PROPOSAL FOR DRAFT AMENDMENT TO GLOBAL TECHNICAL REGULATION 1

(Door Locks and Door Retention Components)

Transmitted by the expert from the United States of America

<u>Figure 1-4</u> – Door Static

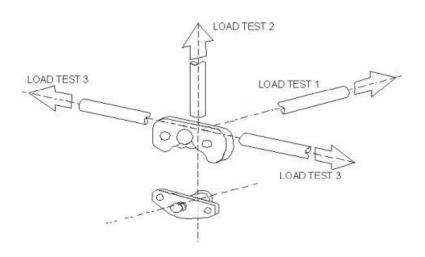
Annex 1, Figure 1-4, amend to show:

Per Informal Document No. GRSP-36-5 submitted by OICA, the arrow of Load Test 1 has been reversed to correctly portray the latch system in tension.
